Burrendong Wind Farm

Submissions Report

Ark Energy

Figure 4-13: Cumulative ZVI with Piambong Wind Farm (Moir Studio 2026)

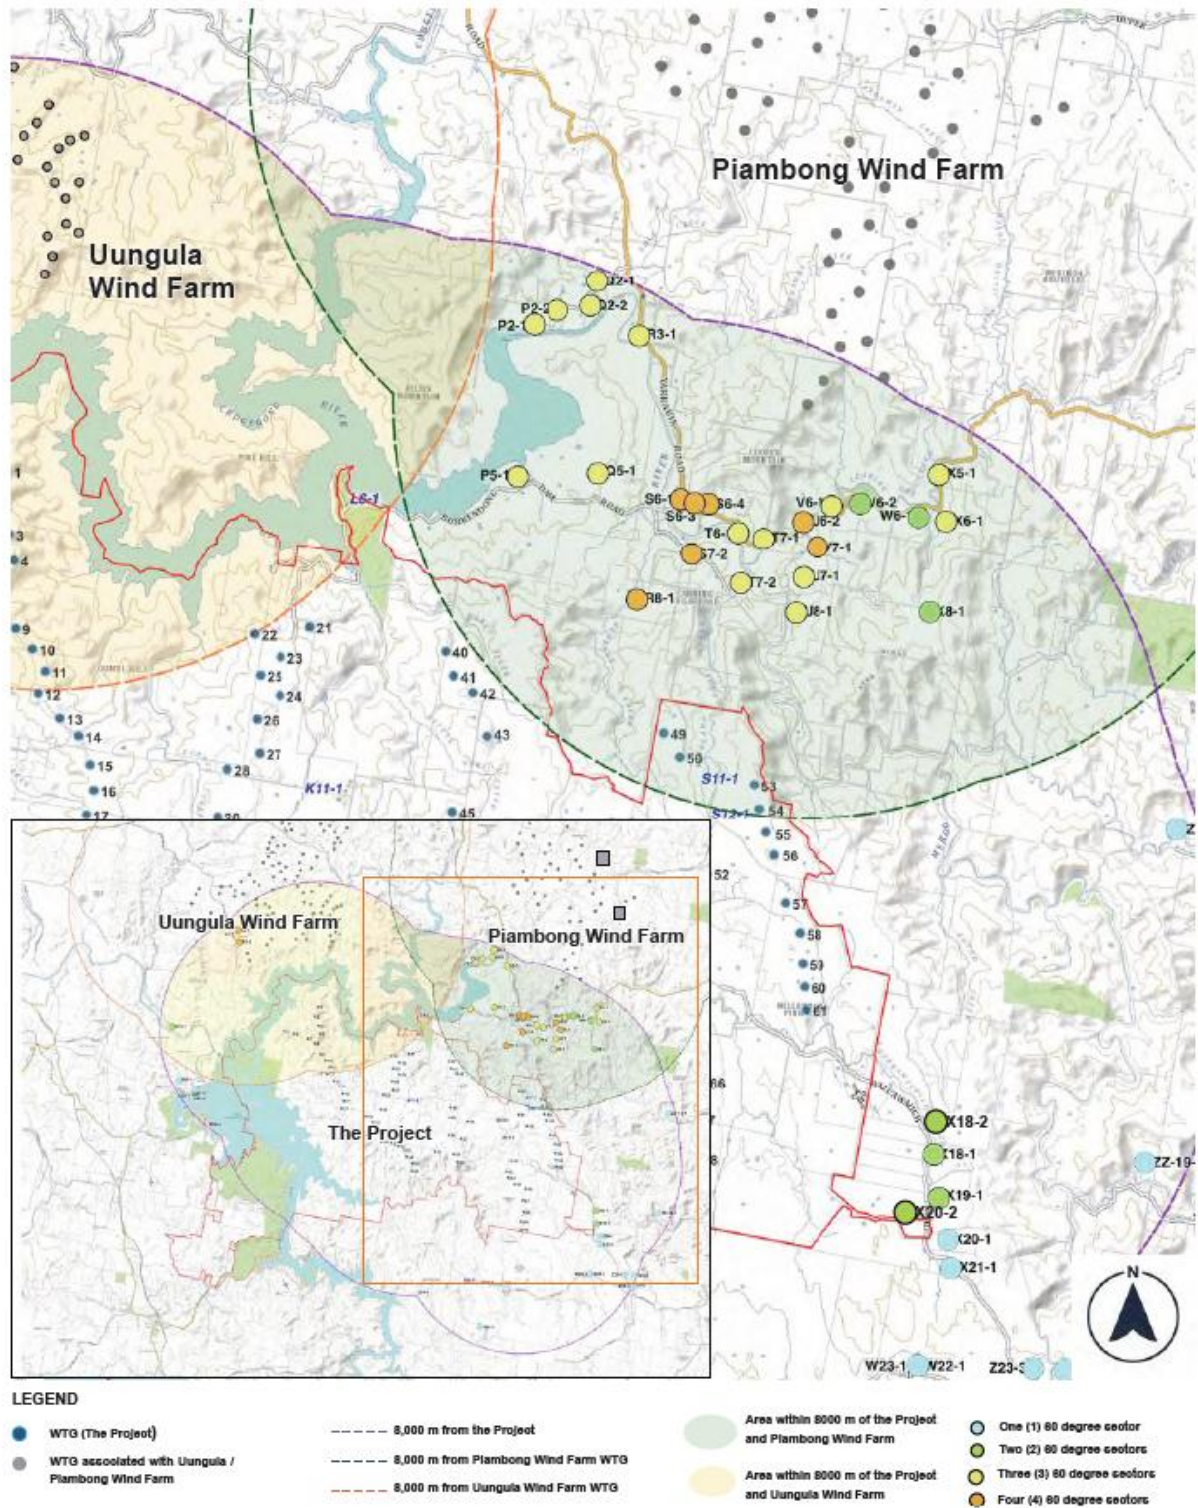
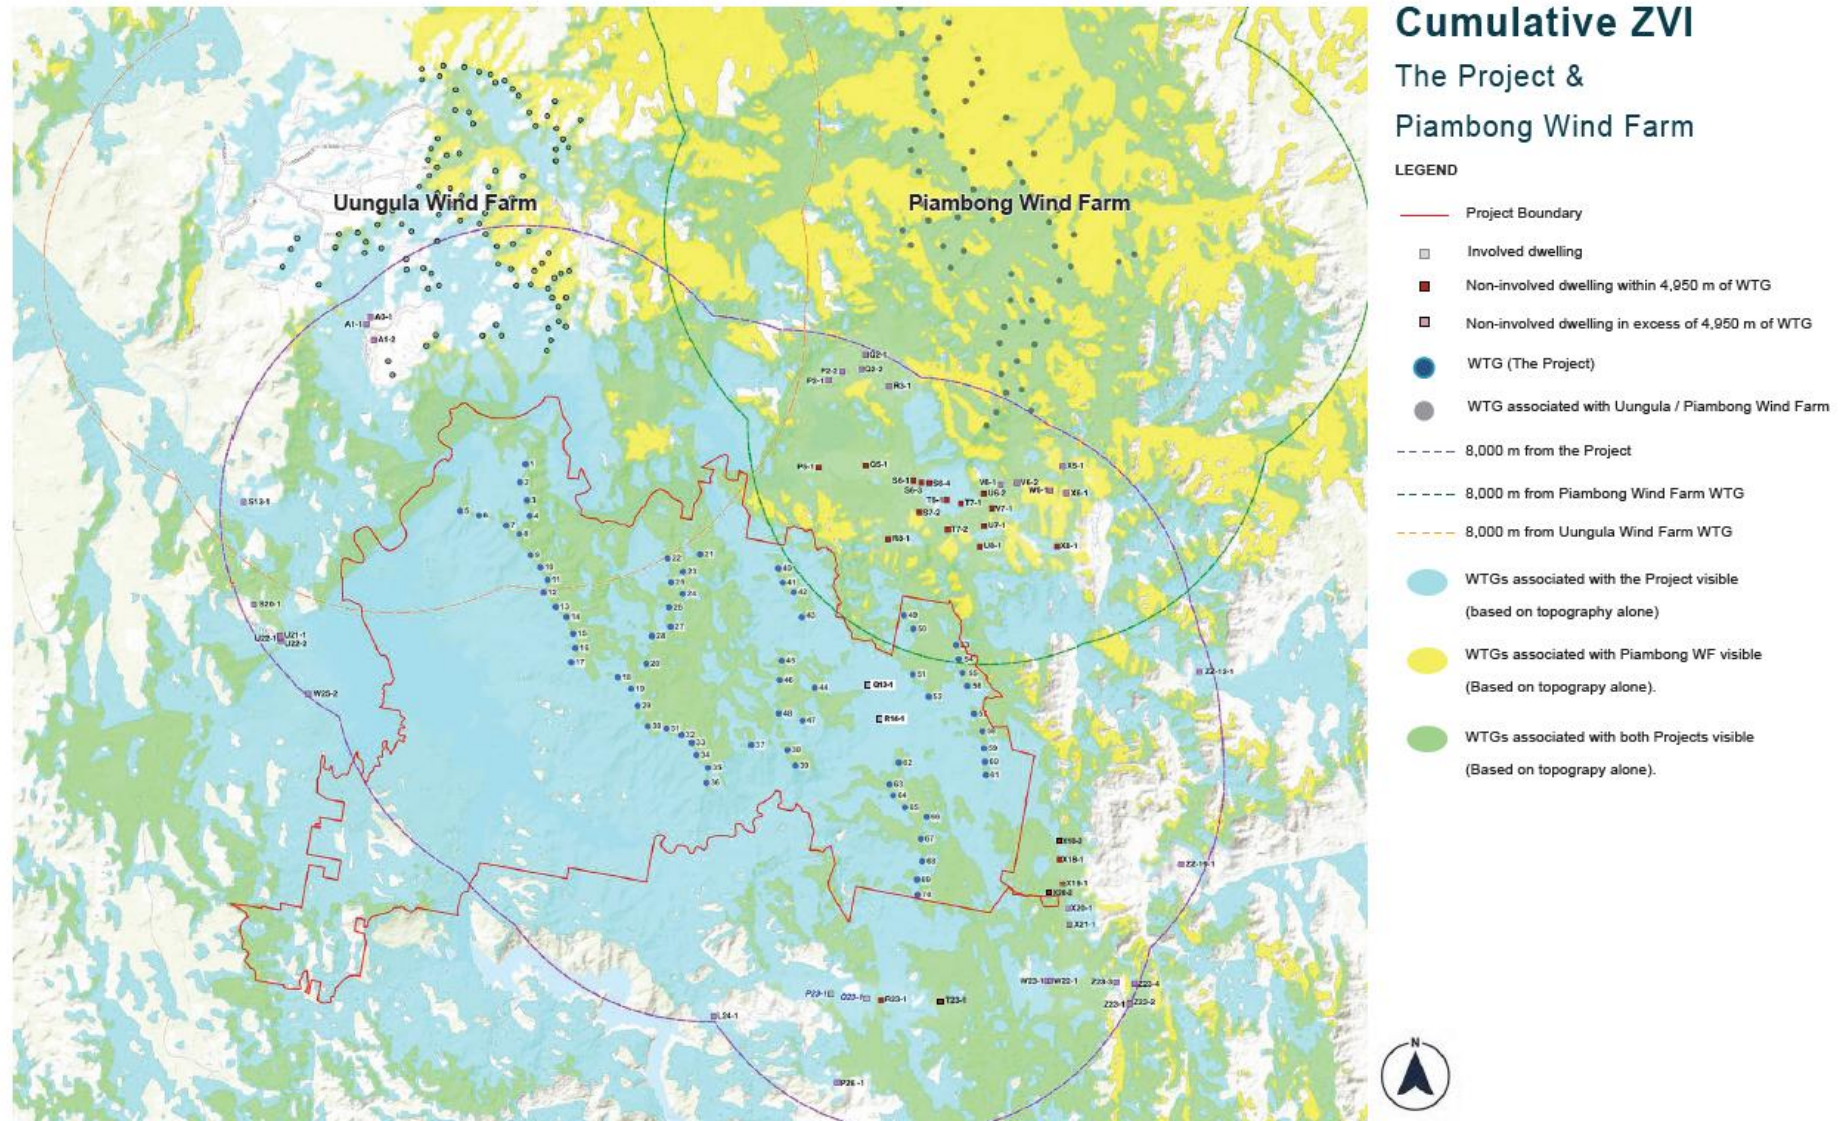
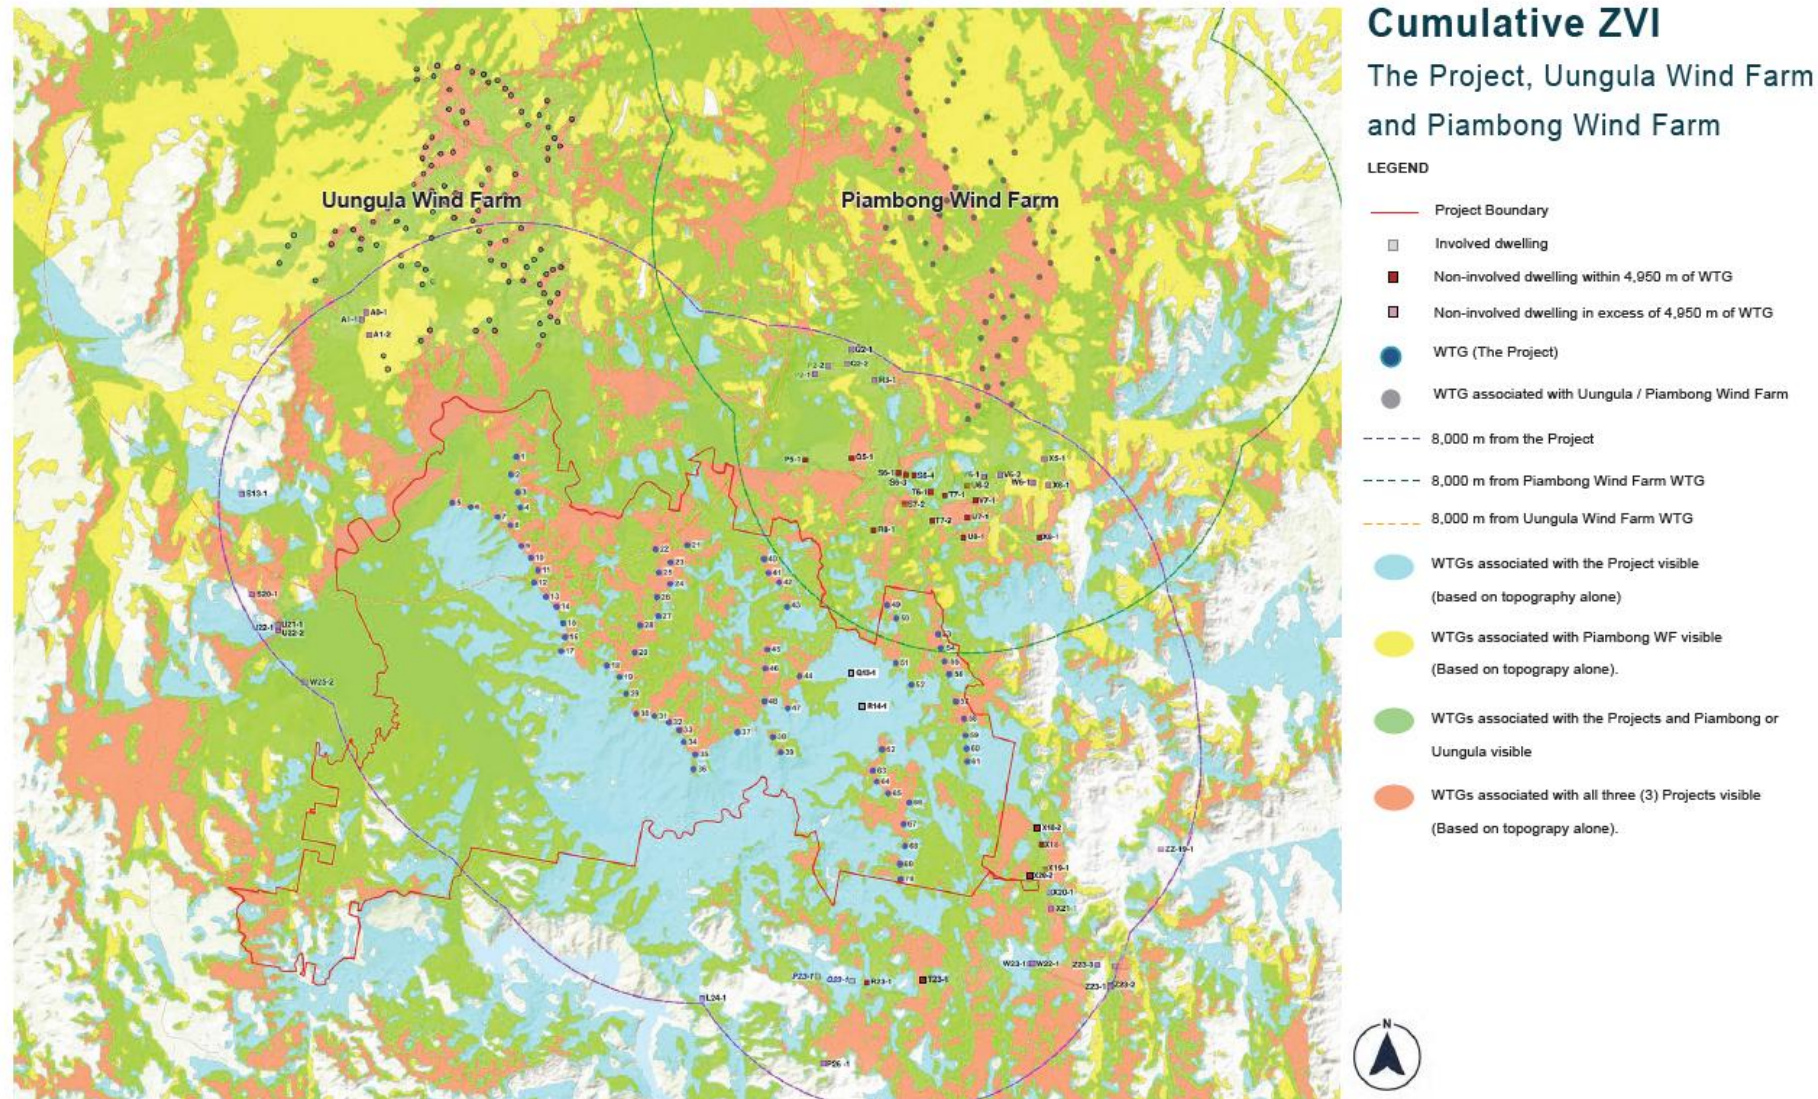
This project is missing from Table 2.1 and importantly missing from the Visual Amenity Assessment. Per Piambong Scoping Report (see page 93 Figure 6-12) the Piambong wind farm is within site distance from this project. It is highlights that some residents will be impacted by 3 wind farms in close proximity- Ungula, Burrendong & Piambong. This has been ignored in this EIS. Council request the Visual amenity is re-done to include this project.

Aside from the application of the MWTT, the Visual Bulletin does not provide a methodology for further consideration of the cumulative visual impacts on the broader landscape. However, to assist in the cumulative visual impact assessment, assessment has been undertaken using viewshed mapping - also referred to as a ZVI figure. Two (2) ZVI figures have been prepared to show areas from which there is the potential to view both the Project and Piambong Wind Farm (Figure 4-13) and areas that all three projects (the Project, Ungula Wind Farm and Piambong Wind Farm) would be visible (Figure 4-14). The ZVI has been determined using digital topographic information and 3D modelling software, WindPro. The ZVI has been assessed to approximately 10 km.

The WTG locations and height (230 m) for the Piambong Wind Farm have been sourced from the Scoping Report as available on the Major Projects Website (December 2023). Due to topography, the ZVI figures illustrate variations in the extent of visibility of each Project. Opportunities to view the Project and Piambong Wind Farm simultaneously are generally limited to land between the two Projects, elevated positions to the far south of the Project and within the Project boundary. As presented in Figure 4-12, there are 25 non-involved dwellings located within 8,000 m of the Project and the proposed Piambong Wind Farm. Of the 25 non-involved dwellings, the ZVI indicates 17 have the potential to view both Projects. The extent of visibility and resulting cumulative visual impact from these dwellings is anticipated to be low as visibility of the Project is limited by topography and intervening vegetation. A detailed cumulative visual impact assessment will be prepared in the EIS for Piambong Wind Farm.

The ZVI prepared for all three (3) projects (Figure 4-14) has illustrated limited visibility of all three projects simultaneously. Opportunities to view all three projects at the same time are limited to land associated with the Project, and the project area associated with Piambong Wind Farm. Additionally, the ZVI identifies some areas of elevated land to the south of the Project have the potential to view all three projects at the same time, however these views would be distant. There are no non-involved dwellings identified within 8,000 m of all three (3) projects.

Figure 4-18: Updated renewable energy projects within proximity to the Project

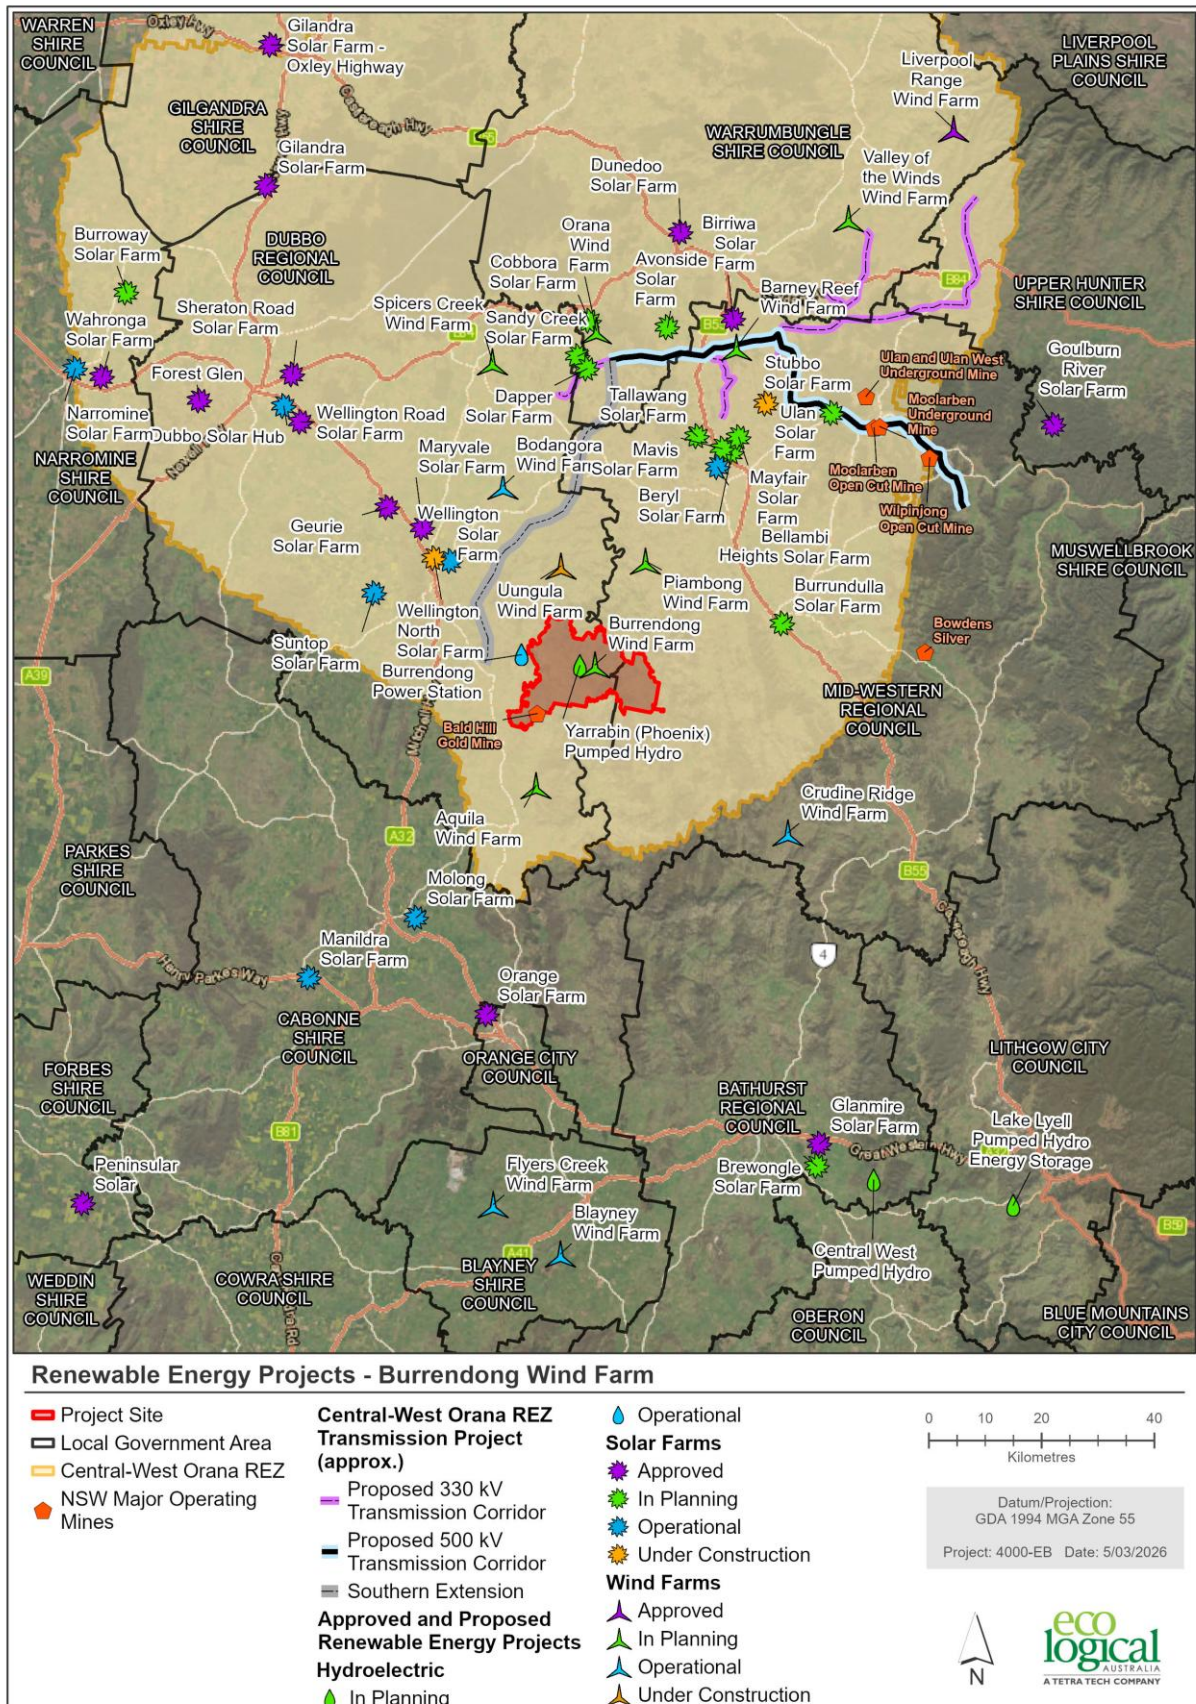
- *Figure 25 of the EIS document is deceptive in showing all of the renewable projects and their impact area. By just including a symbol and not the impact area of each proposal it simplifies the impact and depicts the projects as widespread. However, when all the impact areas are overlayed, they are close together*
- *a number of projects (currently proposed and publicly known) are not listed in the EIS, which have the potential to increase the impact on the communities of Yarrabin, Worlds End, Hargraves Hill and Cudgegong River Valley. This includes the Phoenix pumped hydro and Paimbong wind farm. Who considers this cumulative impact of all the projects?*
- *Paimbong's turbines look set to be closer and more visible even than those of Burrendong. Was not Ark Energy obliged to consider the cumulative effect of this development before lodging their application?*

A submission was received regarding the preparation of a figure showing renewable projects within a 100 km radius of the Project, it has been assumed this submission refers to Figure 2-5 of the EIS (ELA 2023a). The submission referenced a 'deceptive' practice of including a symbol to identify the projects rather than their total

An updated renewable energy project figure has been prepared to include relevant projects that have been proposed since the submission of the EIS and is shown in Figure 4-18 below.
